** Please find our point-by-point response highlighted in blue to the reviewer's comments.

Response to Referee #1: Adam Emmer

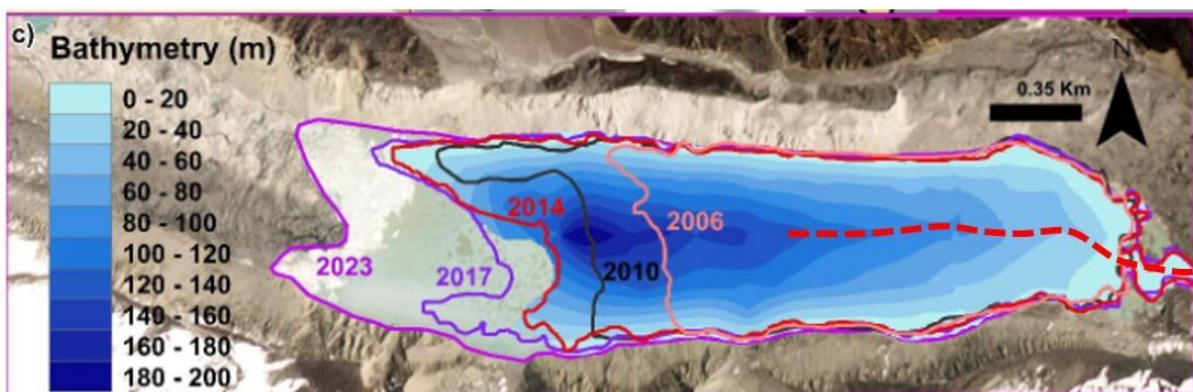
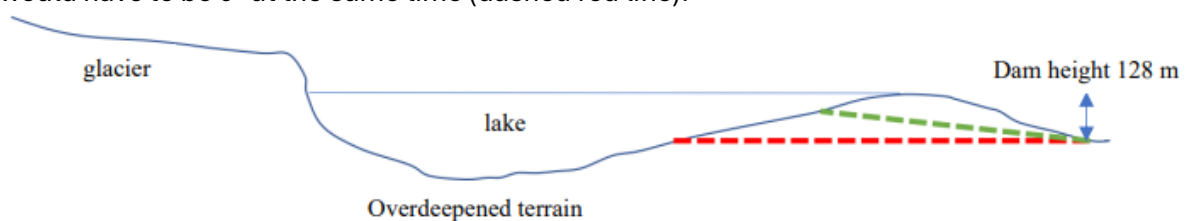
The authors reflected on my comment regarding dam geometry and introduced a characteristic named “dam depth” (“dam height” may be more suitable). However, it is not appropriate to consider that dam height is identical to maximum breach depth. The worst moraine dam breaches reported in the literature are up to several tens of meters deep, however, the authors consider > 100 m for most of the lakes, resulting in the overestimation of what is called the worst case scenario. Here I use the example of Lower Barun lake to illustrate why: The authors estimated the dam height of this lake 128 m (from the toe to the crest) and consider this value the maximum breach depth. Now let’s have a look at the lake bathymetry from Gantayat et al. (2024; <https://doi.org/10.1016/j.scitotenv.2024.175028>):

I draw 128 m deep breach as dashed red line:

Such a breach (here I draw a profile) would have to be > 2,500 m long while its slope would have to be 0° at the same time (dashed red line):

Both these assumptions are unrealistic. In reality, the inclination of the breach channel will be > 0° (schematically represented by dashed green line). And this makes a huge difference. Further, since the lake occupies overdeepened depression, it is unlikely that the dam is even erodible to such depth (bedrock is likely at certain depth or the erosion would stop because of too low slope inclination of the channel).

Therefore, I argue that max. breach depths, flood volumes as well as peak discharges of all lakes with assumed breach depths > 100 m (and resulting flood extents downstream) are overestimated rather than "worst case".

I'm convinced that this issue should be addressed (or at least acknowledged) before the study is accepted for publication. Thank you.

Response: We sincerely appreciate Dr Emmer's valuable feedback. We agree with Dr Emmer's perspective that, for certain lakes, a complete dam breach may be unrealistic due to factors such as the inclination of the breach channel and the specific lithology, composition, and structural characteristics of the dam. Accurately depicting the most severe plausible scenario for each lake requires detailed dam information, and in situ investigations remain the most reliable approach to estimate potential breach sizes. However, obtaining such precise information for all 21 lakes may exceed the scope of this study. Accordingly, we acknowledge this limitation in the manuscript and have added discussion in lines 458-470, including the clarification: "It is recognized that for certain lakes, a complete (100%) breach may be improbable and represents only a theoretical worst-case scenario. In practical terms, the most severe realistic scenario should consider the unique lithology, composition, and structural characteristics of each moraine dam". Additionally, we have reviewed the manuscript to ensure consistency, replacing terms such as "the worst situation" with "theoretical worst situation/scenarios, i.e., a complete breach of dam height". Beyond the 100% breach scenario, we evaluated breaches at 10%, 30%, and 50% of dam height in section 4.3.1, aiming to provide a comparative perspective for each lake and offer more practical insights. 'Dam depth' has been revised to 'dam height' throughout the manuscript.

Lines 458 – 470: We evaluate GLOF scenarios involving breaches of 10%, 30%, 50%, and 100% of dam heights. It is recognized that for certain lakes, a complete (100%) breach may be improbable and represents only a theoretical worst-case scenario. In practical terms, the most severe realistic scenario should consider the unique lithology, composition, and structural characteristics of each moraine dam; however, conducting such detailed field investigation to gather this information across multiple lakes at a large scale remains challenging. For large-scale GLOF risk assessments, Zhang et al. (2023) applied an empirical relationship between lake volume and flood volume, derived from historical GLOFs, to estimate flood volumes, capping the maximum flood volume at $20 \times 10^6 \text{ m}^3$ due to limited data on large glacial lakes. Fujita et al. (2013) estimated potential flood volume by analysing the depression angle from lake shorelines using DEM data, noting that potential flood volume is helpful for preliminarily identifying and prioritising lakes for further investigation but does not directly quantify GLOF risk. As no straightforward and reliable method currently exists for accurately predicting flood volumes across multiple lakes, we analysed scenarios assuming breaches at 10%, 30%, 50%, and 100% of dam heights for consistency. When interpreting these impact results, the inherent limitations in predicting flood volume and the realistic likelihood of each scenario should be carefully considered.

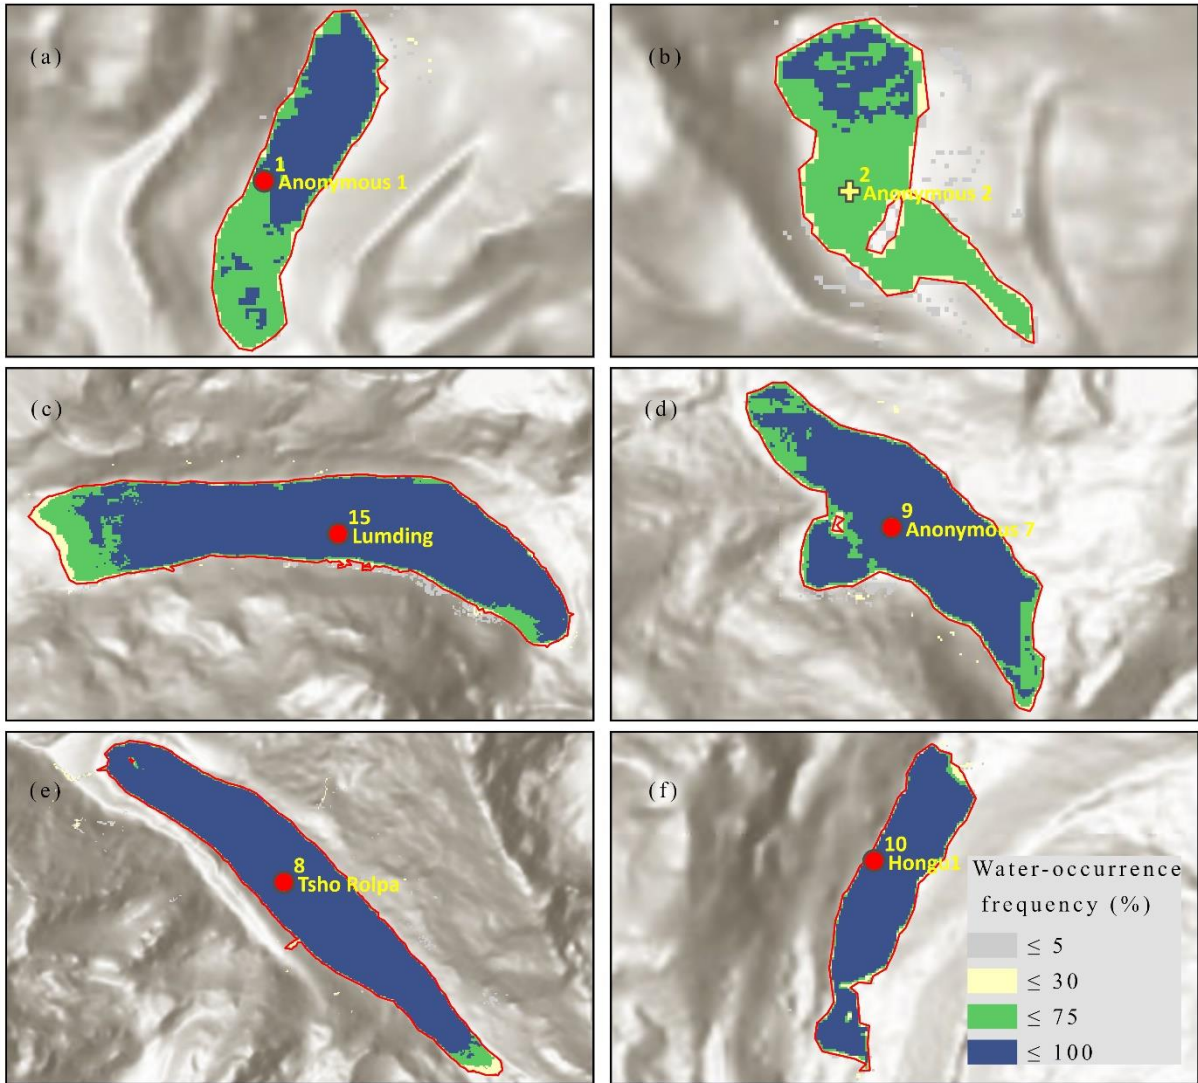
Fig. 3: I don't see the need to keep panel (a) as: (i) it still contains lake classification, and (ii) the lake indices have been shown in fig. 2.

Response: We have removed panel (a) and now display six panels below in Fig. 2.

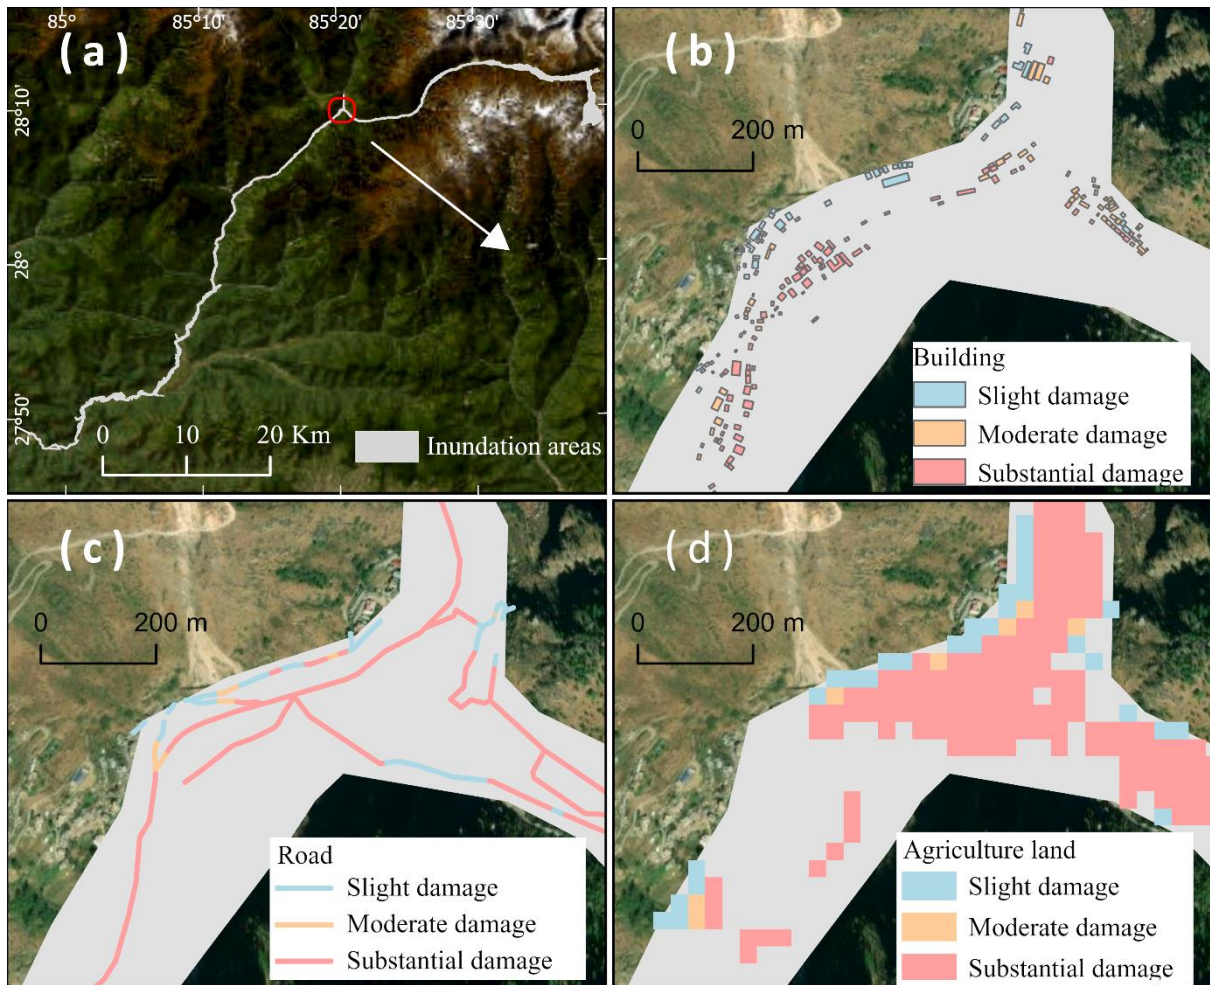
Fig. 8: Scales are needed for all the panels.

Response: Scales has been added in Fig. 8.
